TRANSPORTATION IMPACT ANALYSIS

PROPOSED OFFICE BUILDING AT 425 VALLEY DRIVE
(Brisbane, California)

Subject: Requirement of Separate Left-Turn Lanes on Valley Drive at the Valley Drive/
N. Hill Drive-S. Hill Drive Intersection
1005-237

Date: November 18, 2004
To: Tim Tune
 Senior Planner
 City of Brisbane
 50 Park Place
 Brisbane, CA 94005
From: Matt Haynes, PE, Fehr & Peers
Subject: *Valley Drive and South Hill Drive Intersection Distribution for 425 Valley Drive*
 1047-0151/LB

FIGURE 1
 SITE PLAN

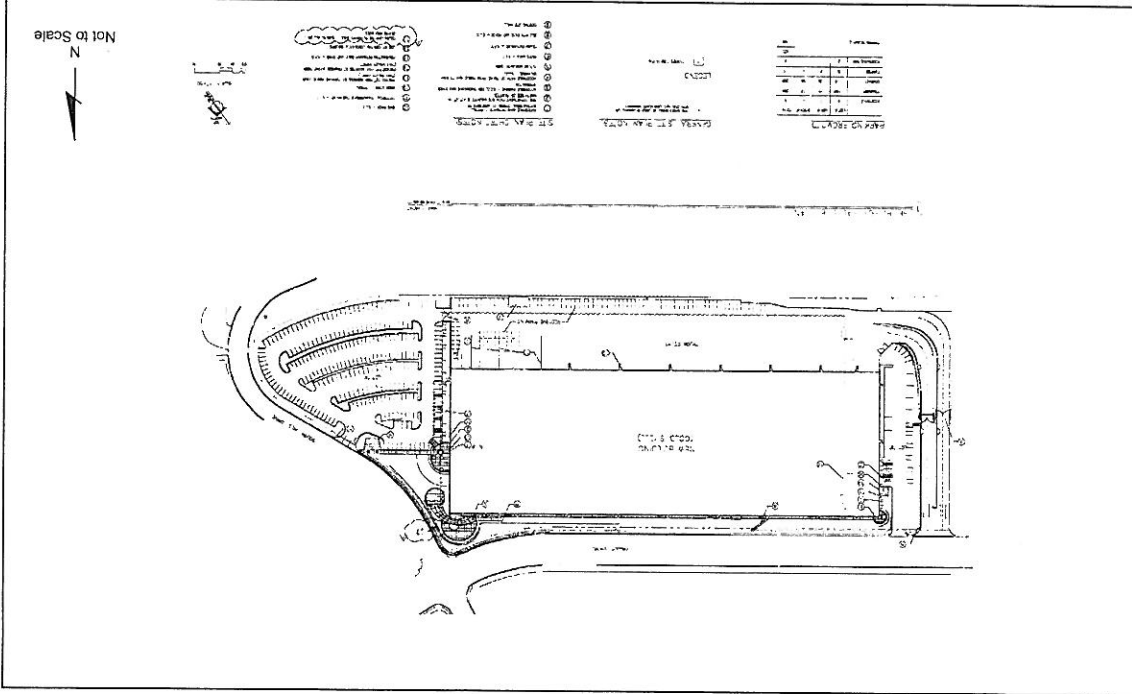
As shown in the site plan (Figure 1), the site will have three driveways, two on Valley Drive and one on South Hill Drive. The driveway located off South Hill Drive and one of the driveways off of Valley Drive are designed for non-truck access to on-site parking. The second driveway located off of Valley Drive is designed for truck access to the warehouse facilities. No truck traffic to the site will make a westbound left onto Valley Drive to access the project site.

Inbound vehicles using the South Hill Drive entrance will make a left-turn at the study intersection onto South Hill Drive. Trips generated by the office space were assigned to the driveways according to the number of parking spaces in each parking lot. According to the site plan (dated May 7, 2004) Lot A, with access off of South Hill Drive, will have 258 parking stalls and Lot B, with access off of Valley Drive, will have 60 parking stalls. Therefore, it was assumed 81 percent of inbound office generated project trips, 88 AM peak hour and 16 PM peak hour, will access parking Lot A after executing a westbound left-turn at the study intersection.

The previous site had truck access to the warehouse on both Valley Drive and South Hill Drive. We estimated 50 percent of inbound warehouse traffic and all office traffic previously accessed the site via the South Hill Drive entrance after executing a westbound left-turn at the study intersection.
